Product Change Notification

TRIMPOT® TRIMMING POTENTIOMETERS

Bourns® Model 3329P-DK9, PV32P, RJ50, and RJR50 Round Trimming Potentiometers *Change to Packaging Tube*

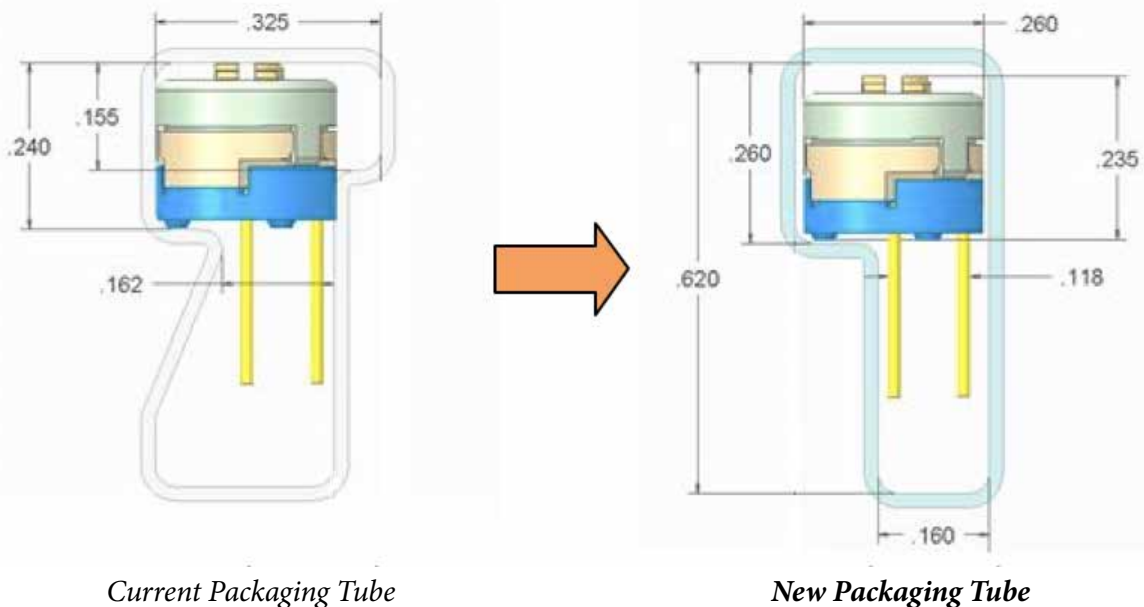
Bourns is pleased to announce an upgrade to the packaging tubes for the [Model 3329P-DK9](#), PV32P, [RJ50](#) and [RJR50](#) Round Trimming Potentiometers. The new packaging tube will be shaped much like the trimmer itself, rather than the less efficient shape that is currently being used.

There are no changes to the form, fit, function, quality or reliability of the trimmers themselves. The packaging tube's fit (physical dimensions) and form (the appearance, such as the shape) will be changed. A list of the affected part numbers is shown in Table 1 on the next page.

Date that manufacturing of existing product packaging will cease: July 26, 2016

Date that deliveries of modified product packaging will begin: July 27, 2016

First date code using above changes: 1631C
